ACTION TRANSMITTAL No. 2013-34

SUBJECT: Scope Change Request for Bridge No. 9 over the Mississippi River at the University of Minnesota

RE: TE-09-13 - Bridge No. 9 (MnDOT 94246)
Bridge 9 over the Mississippi River Substructure Rehabilitation
and Superstructure Painting Scope Change
SP 141-090-038

SITE LOCATION
SCOPE CHANGE
BRIDGE NO. 9 PEDESTRIAN BRIDGE
MINNEAPOLIS, MINNESOTA

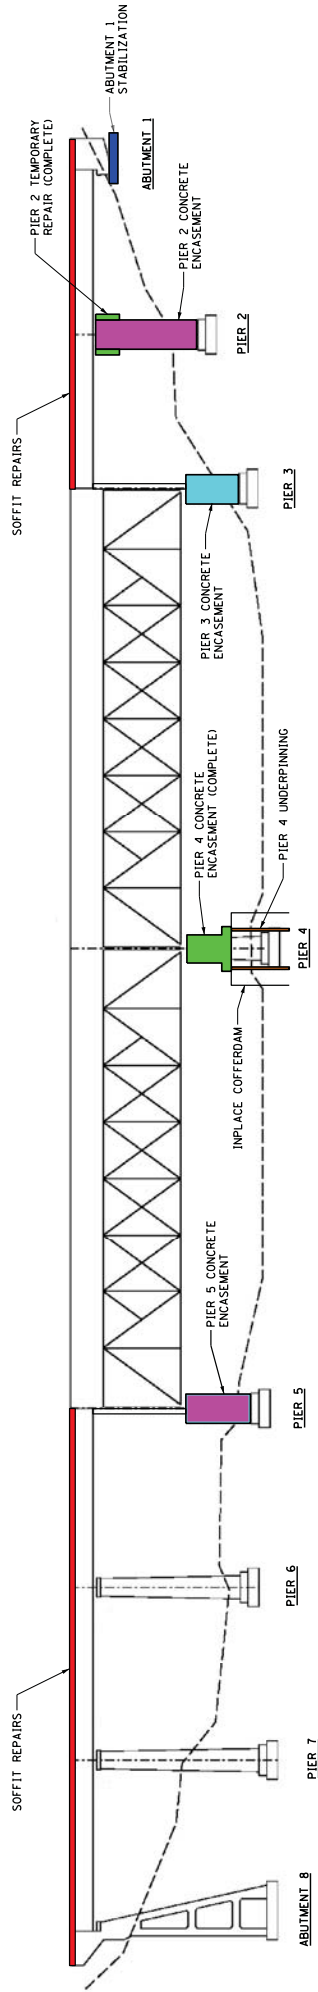
The City directed ONE to develop repair plans to address the critical finding. Emergency repairs were immediately initiated to address pier & bearing support conditions at Pier 4 (river pier) and Pier 2 (see attached Elevation Plan for pier locations) to allow pedestrian traffic to remain on the bridge. This work was completed by City of Minneapolis forces in fall & winter of 2012 and 2013. The cost of the work exceeded \$700,000.

The repairs required at Pier 4 and Pier 2 are more extensive than the anticipated in the 2009 report. Concrete encasement was provided at Pier 4 from the top of cofferdam to the pier cap to prevent truss bearing support failure. A post-tensioned steel clamping fixture was installed at Pier 2 to accomplish the same objective. Additional work is necessary at both piers to complete these repairs. At Pier 4 a deep foundation system is needed to underpin the concrete encasement. At Pier 2 concrete encasement is required for the full height of the pier column to provide a permanent solution.
